Re: Third Submission Review – Green Valley Ranch East Site Plan No 6 Amdt 1 – Site Plan Amendment and Replat
Application Number: **DA-1662-33**
Case Numbers: 2023-3055-00; 2021-4012-01

Third Submission Review

GREEN VALLEY RANCH EAST SITE PLAN #6

Project Number:	50119125
Designed By:	Drawn By: CJR
Checked By:	GD
WAZ	
Sheet Number:	9

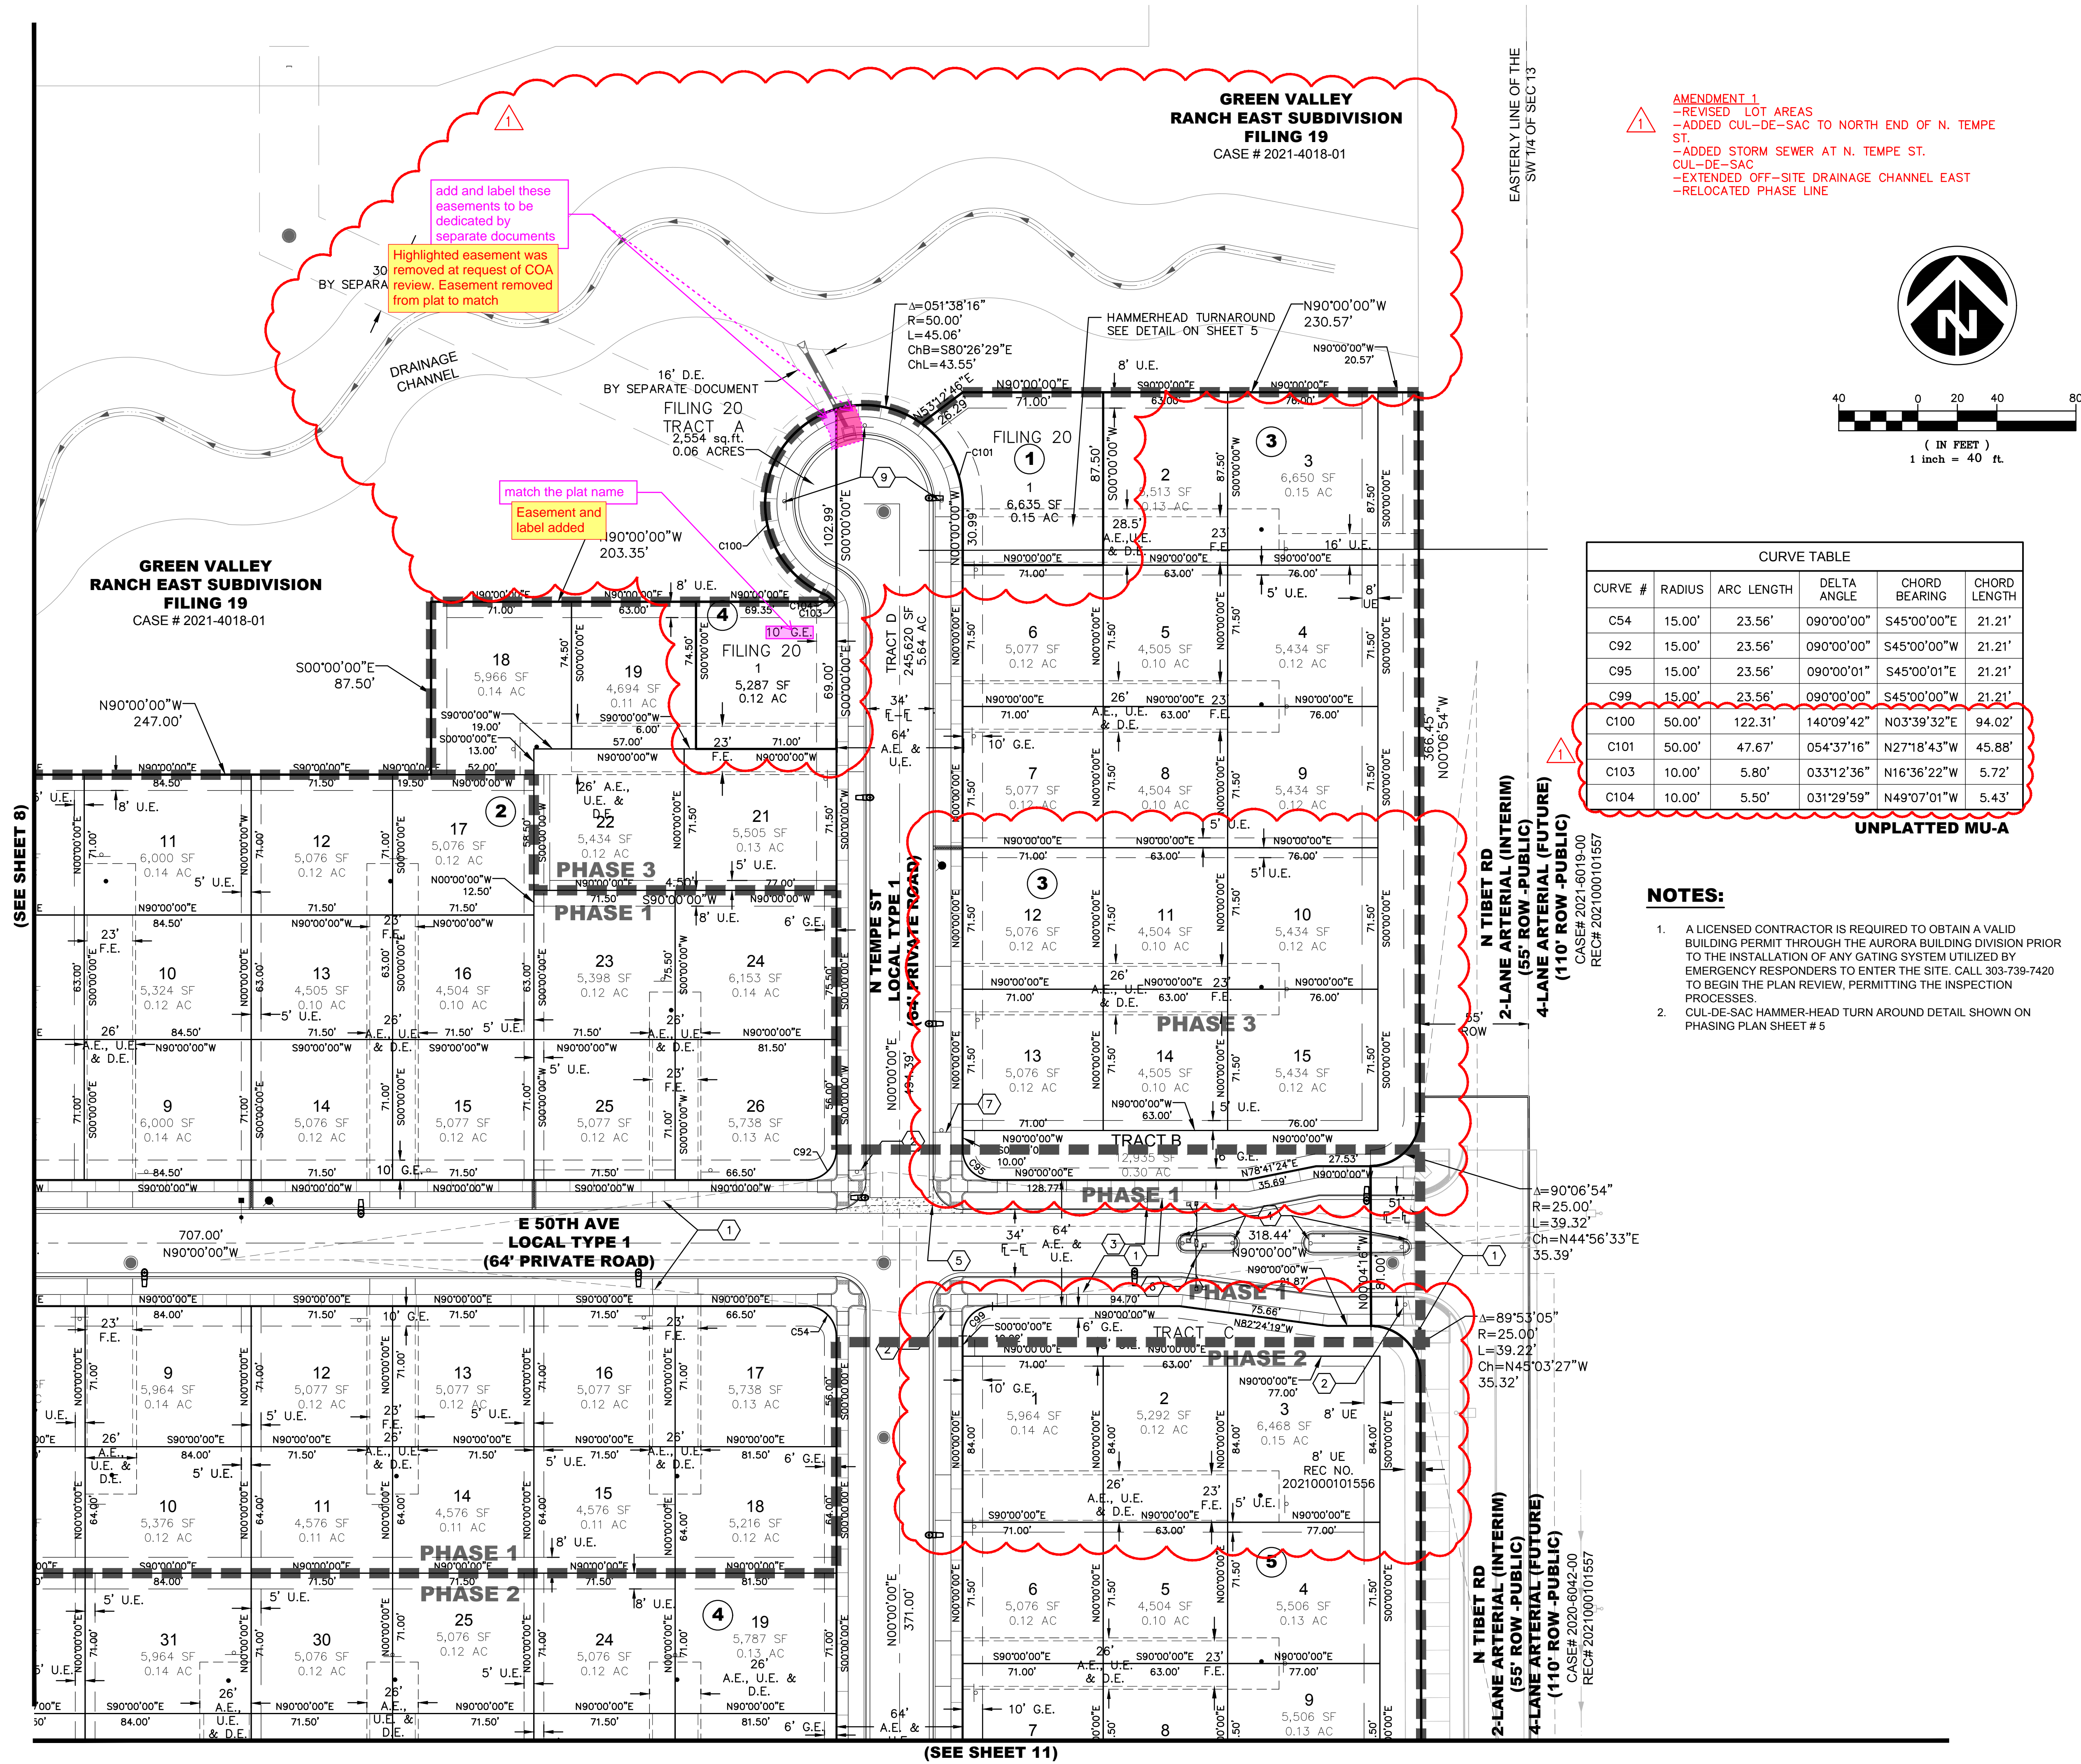
3A. Add and label the easements to be dedicated by separate document noted on Sheet 9. **RESPONSE: Easement around the sump inlet at the N Tempe St cul-de-sac was removed at request of Aurora Water reviewer. Easement linework has been removed from the plat to match the site plan**
